1. AMCOMMAND II 8225-HP/28/FDH Two-Diver Control System
 2. Pressed Steel Tank, Co. High-Pressure Steel SCUBA Cylinders
 3. Zeagle OCTO+ MKII Regulator/BC Inflator Combo Unit
 4. Ocean Management System (OMS) IQ 4 BC/Backplate Harness System
-

Re: Pac Endorsement comment 7.(a)(14)... Our contacts at the Naval Safety Center in Norfolk responded to my question with the answer below. I am having HEALY weigh sample full tanks so we don't need to refer to the Navy's report. I will attempt to get the "per manufacturer" info stated below, directly.

ENCLOSURE(8)

Middle Ear Barotrauma

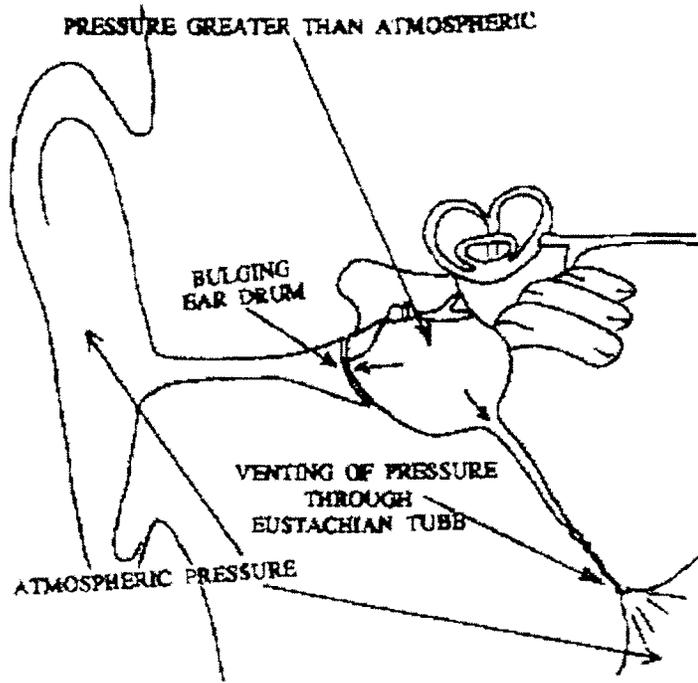
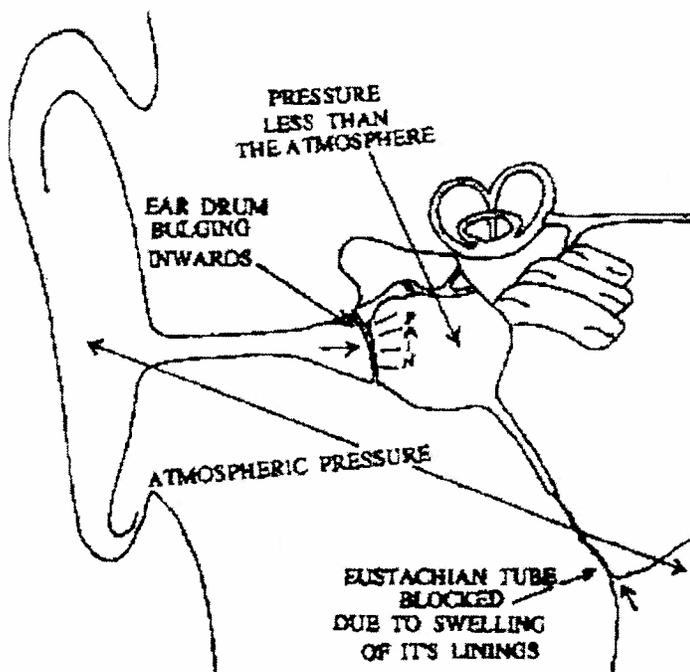
Re: Pac Endorsement comment 7.(a)(17)... The AIM board mentioned inner ear squeeze and PAC contends the term is middle ears squeeze.

Middle ear barotrauma is caused by the inability of the diver to clear the space in the middle ear through the Eustachian tube and has been described by MacFie and placed in TEED types I through IV. This diagnosis is made on the basis of pain on descent and physical examination shows redness of the tympanic membrane due to hemorrhage and occasionally free blood in the middle ear cavity. MacFie has types I through V, Pullen describes mild, moderate and severe.

Nature abhors a vacuum, so negative pressure in the middle ear retracts the ear drum and fills the middle ear with fluid.

To prevent **middle ear squeeze**, equalize frequently during descent by auto-inflation. The diver should dive feet first, which reduces venous engorgement of the head, sinuses and eustachian tube. The head down position produces a closure of the sinus ostia or eustachian tube.

During descent, unequal pressure causes an inward bulging of the tympanic membrane, which will continue unless the middle ear pressure is equalized. Fluid pressure within the inner ear equals that of the water surrounding the diver and with continued descent the pressure in the external auditory canal increases. Unless the pressure is equalized, round window rupture or tympanic membrane rupture may occur with as little as 100mg Hg difference between the external auditory canal and the middle ear. This change in pressure can be as little as 4 feet sea water.
